# City of Richmond

## Report to Development Permit Panel

**File:** DP 15-708644

**Re:** Application by Yamamoto Architecture Inc. for a Development Permit at  
7260 Lynnwood Drive and 5320, 5340 & 5360 Granville Avenue

CONVERTIBLE

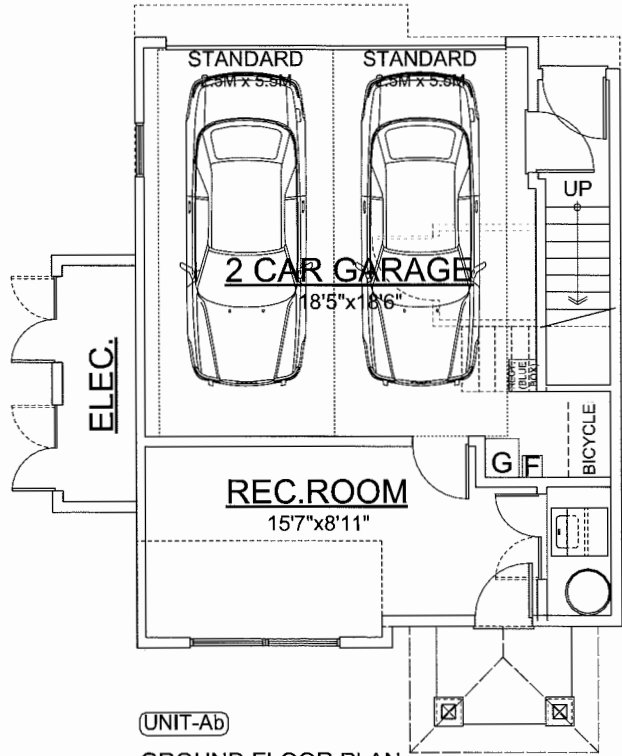
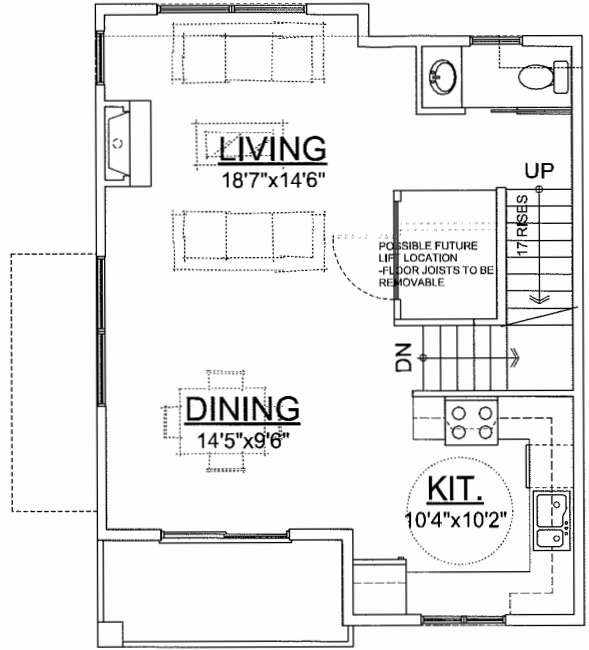
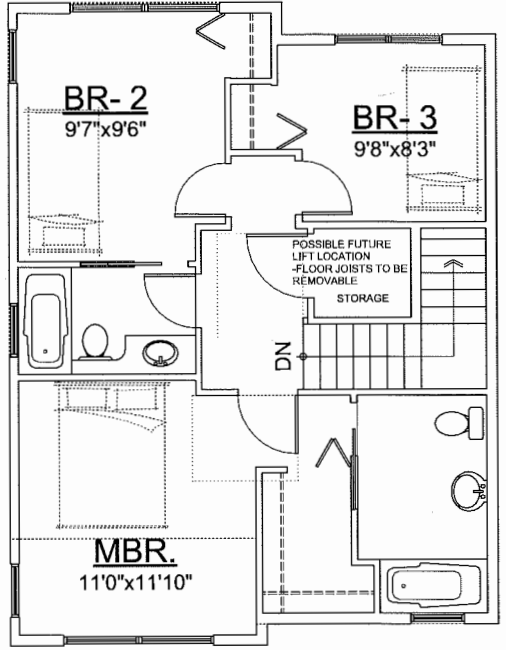
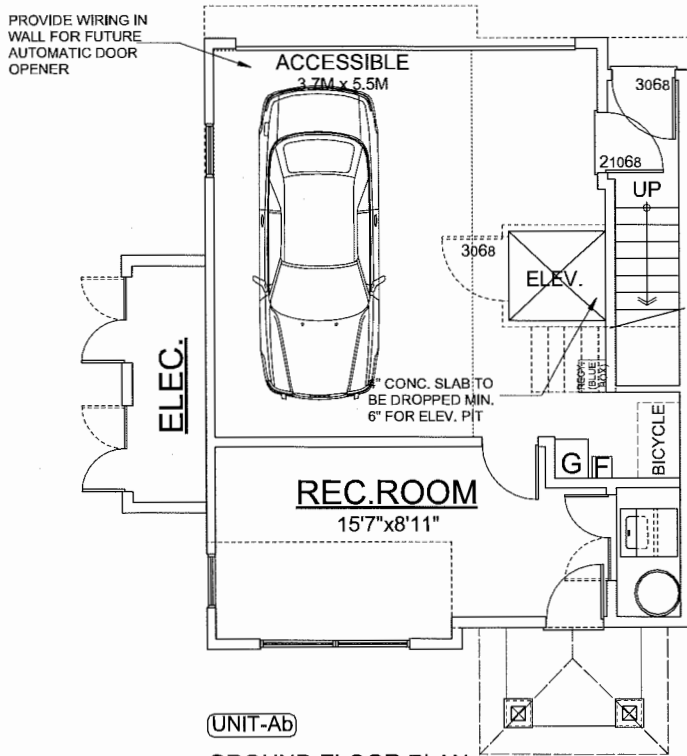
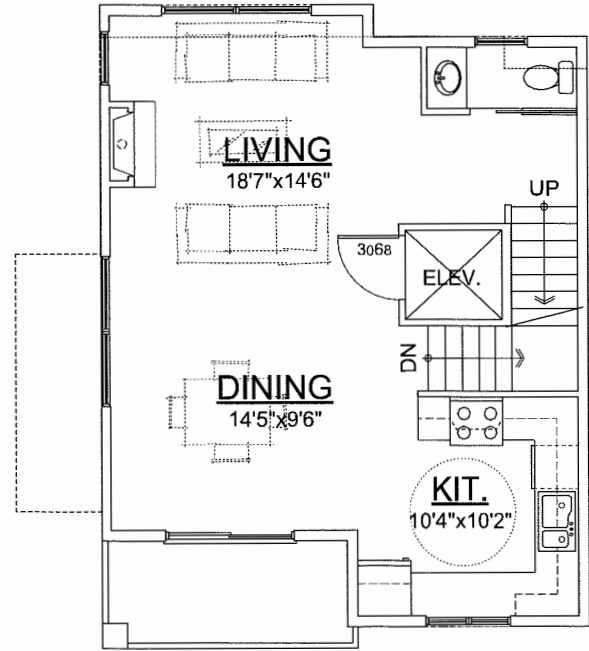
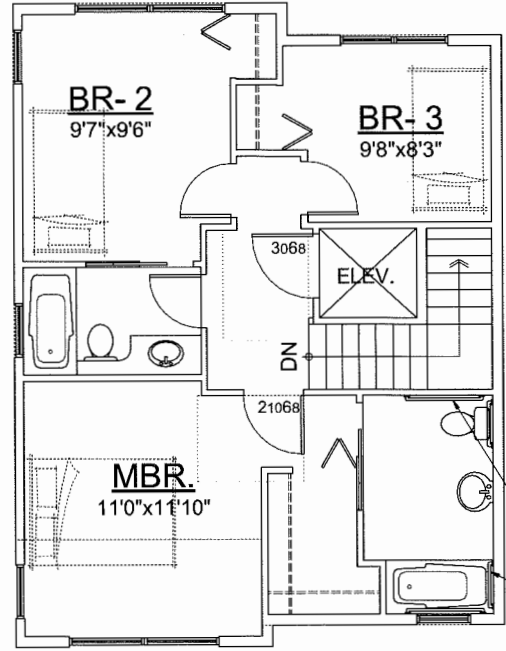
- appreciate the pocket doors for the washrooms – *Noted.*
- review the kitchen work surface lay-out for the convertible unit; consider locating the sink between the stove and refrigerator for a more efficient work area – *Done.*
